## Base document for ALKS for low speed application prepared by co-chairs

### Proposal for Technical Requirements for an Automated Lane Keeping System

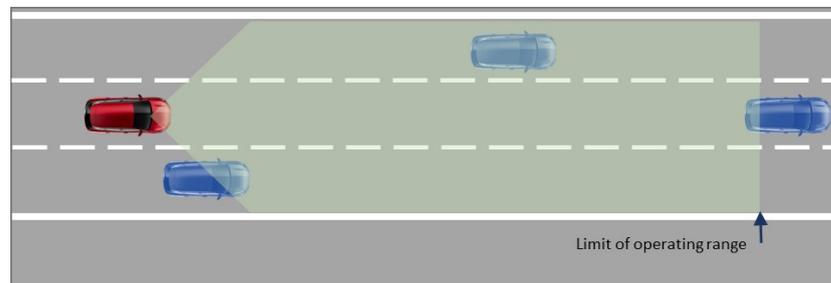
*Comment to the table above: The table is derived from the Korean proposal in document 22.09 The values are rounded to ease the understanding and are capped at 2.0 seconds to align with the original proposal from Germany and OICA. For*

*low speed systems the table could end at the corresponding max. operational speed.*
